Application No. 10/616,238  
Amendment Dated November 22, 2004  
In Reply to Office Action dated July 23, 2004

**Remarks**

FIG. 1

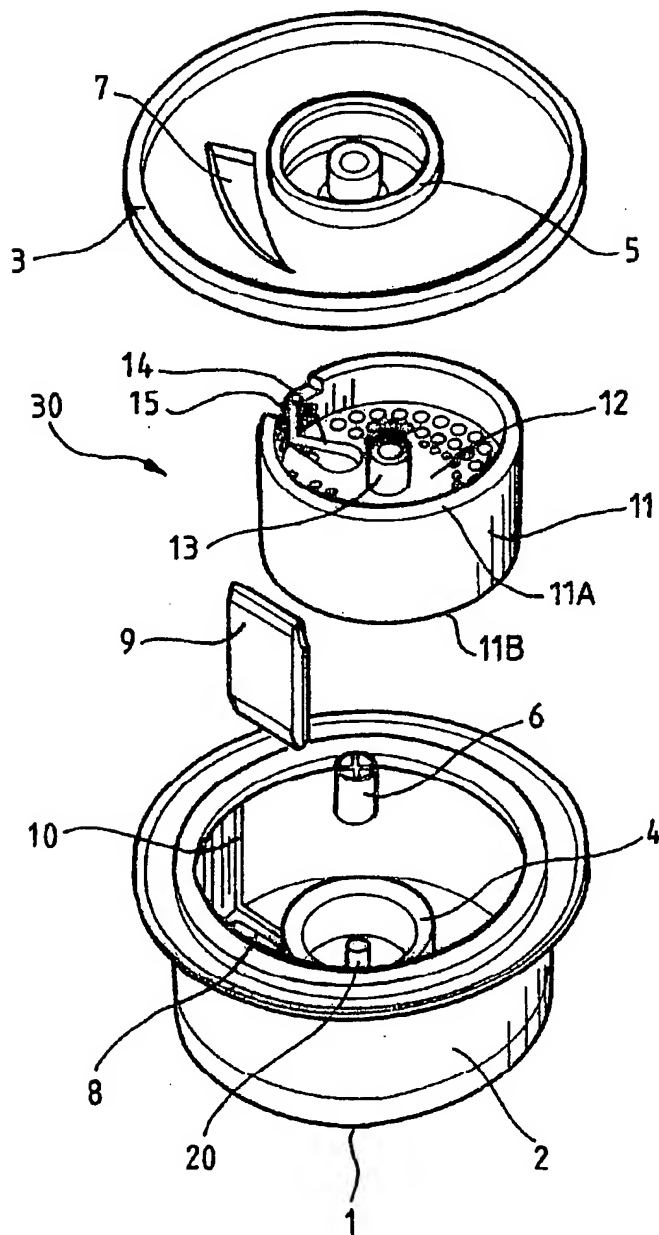
In paragraph 2 of the Office Action, the Examiner has objected to Figure 1 because it does not include the legend "Prior Art." Applicants have amended Figure 1 accordingly, and respectfully request that this objection be withdrawn.

The attached sheets of drawings include changes to Figures 1 and 2. Sheet 1, which includes Figure 1, replaces the original sheet 1 including Figure 1. Sheet 2, which includes Figure 2, replaces the original sheet 2 including Figure 2. In Figure 1, the legend "Prior Art" has been added. In Figure 2, the element number "16" has been added.
